Refer to: HSA-10/SS-121

Thank you for your letter of November 13, 2003, requesting Federal Highway Administration (FHWA) acceptance of the MTC SAFE ITS Callbox support as a breakaway sign support system for use on the National Highway System (NHS). Accompanying your letter was a report from the Texas Transportation Institute and videos of the crash tests. You requested that we find the MTC SAFE ITS Callbox breakaway supports acceptable for use on the NHS under the provisions of National Cooperative Highway Research Program (NCHRP) Report 350 "Recommended Procedures for the Safety Performance Evaluation of Highway Features."

Figure 1. Details of the ITS Call Box.

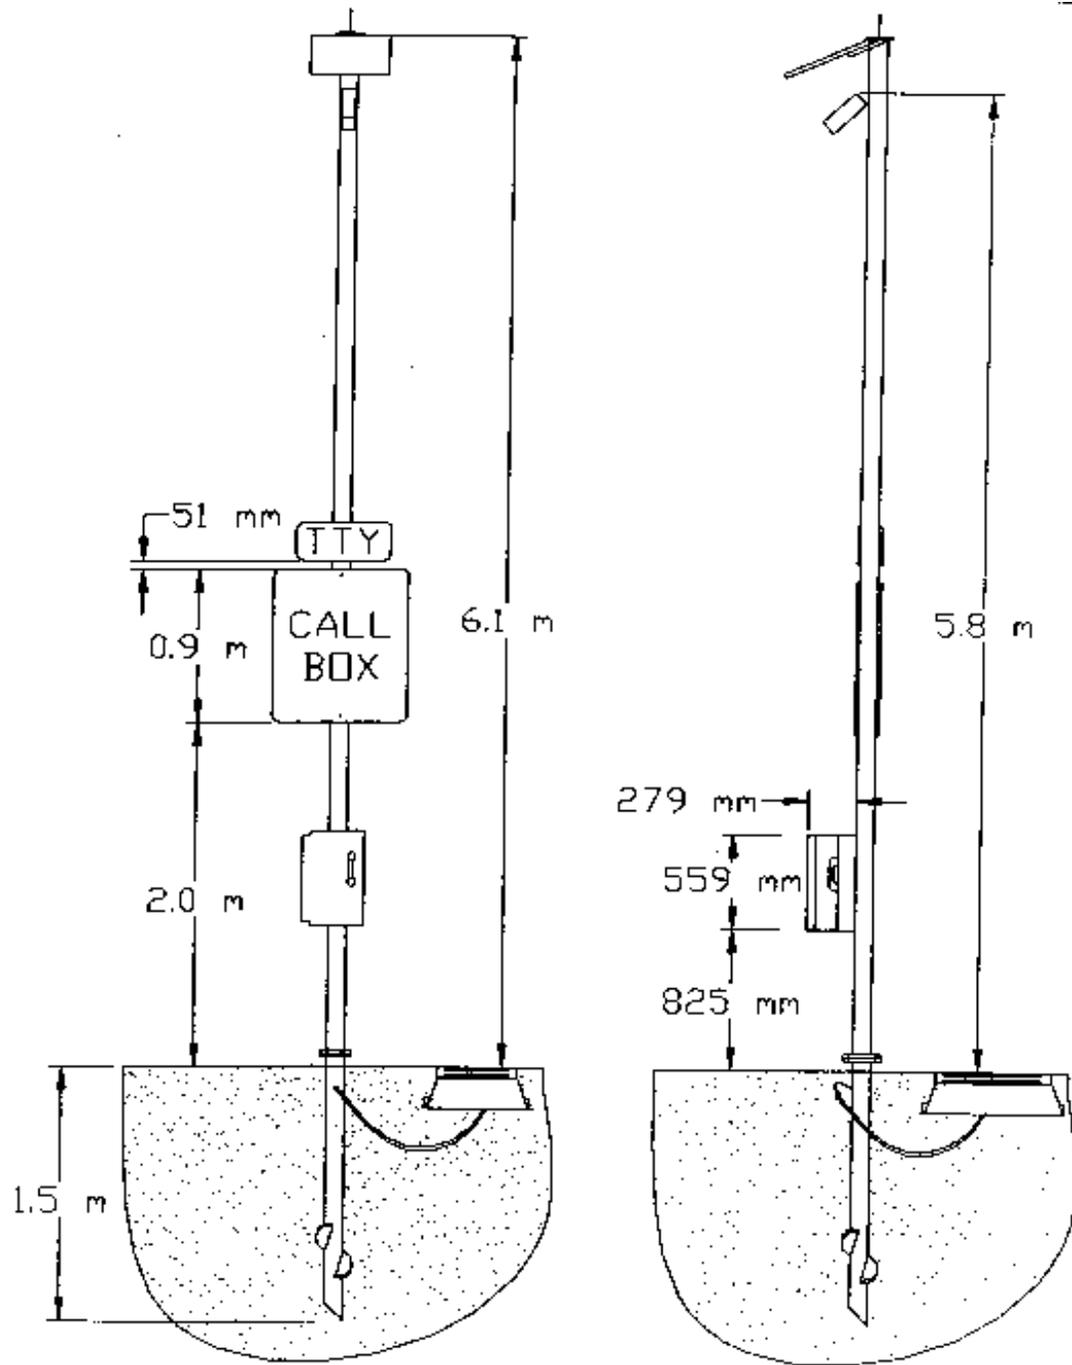
Two 762 mm x 914 mm (30 inch x 36 inch) call box sign panels and two 254 mm x 508 mm (10 inches x 20 inches) TTY sign panels were attached back to back to the support pole. At the top of the support was a pole cap with a 20 watt solar panel (34 mm x 430 mm x 530 mm) and antenna. A simulated CCTV camera, weighing 3.8 kg (8.4 pounds) was mounted to the support 5793 mm from the ground. A drawing of the tested system is enclosed for reference.

Damage was limited to the front bumper, hood, radiator, roof, and rear hatch, with no windshield contact occurring in either test. Velocity changes were all within acceptable limits, and the only stub remaining was the 76-mm tall lower slip plate. The results of testing met FHWA requirements and, therefore, the devices described above and shown in the enclosed drawings for reference are acceptable for use as Test Level 3 devices on the NHS under the range of conditions tested, when proposed by a State. Because the occupant impact speed was well below the "desirable" limit of 3 m/s, the additional weight of the battery will not have a significant effect on the breakaway performance of the system.
